Reference: 245 Great Western Highway, South Wentworthville

Background

This letter has been prepared in response to TfNSW submissions seeking further information in relation to the proposed mixed-use development comprising new hotel/ motel and adaptive reuse of the existing heritage building for use as a café/ restaurant on the site at 245 Great Western Highway, South Wentworthville.

Figure 2: Line of sight on horizontal curves

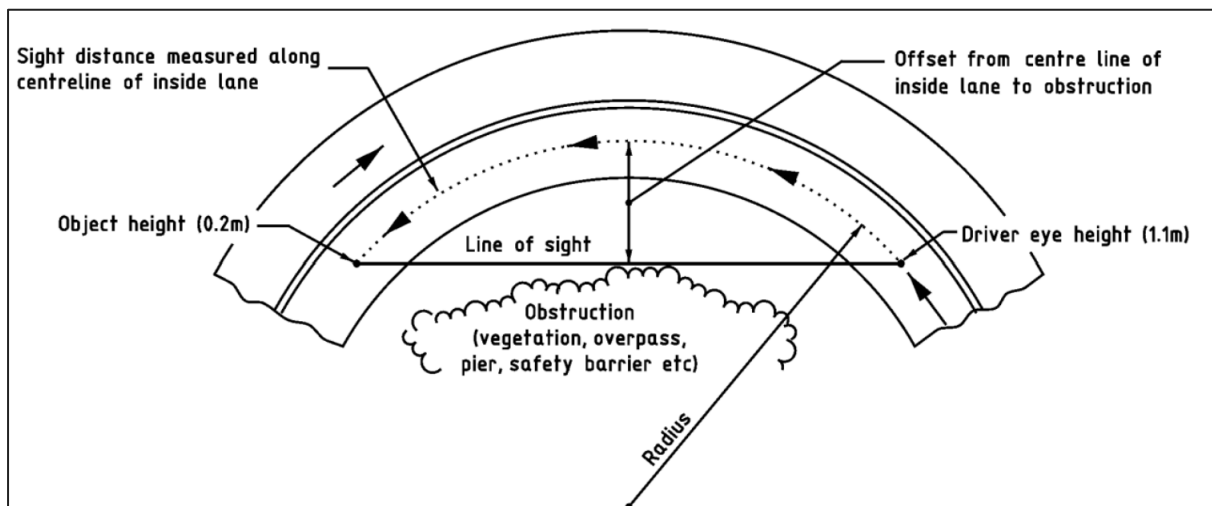
Concerns are raised relating to the safety of the proposed entry access arrangements to the site noting its proximity to the adjacent traffic signals. Due to the size of the proposed development and the location of the proposed entry access being both near a slight bend and the adjacent traffic signals there is the potential for multiple vehicles to be briefly queued upon entry to the site. This has the potential to compromise road safety at this point along the Great Western Highway not just for westbound motorists but also for buses.

In order to understand the sightline requirements at the entry driveway, an assessment of the Approach Sight Distance (ASD) for heavy vehicles is important. This is due to the dedicated bus only lane along the site frontage and absence of general traffic in this lane.

ASD requirements for trucks (and buses) are outlined in Table 5.6 of *Guide to Road Design Part 3: Geometric Design* (Austroads, 2021), reproduced in Figure 1 and shown diagrammatically in Figure 2.

Figure 1 indicates that for a 60km/h operating speed and application of a 1.5 second reaction time, the corresponding ASD is 74 metres. For a design speed of 70km/h, the corresponding ASD would be 96 metres. The maximum (most conservative) sight distance based on a 70 km/h design speed and 2.5 second reaction time requires an ASD of 115 metres.
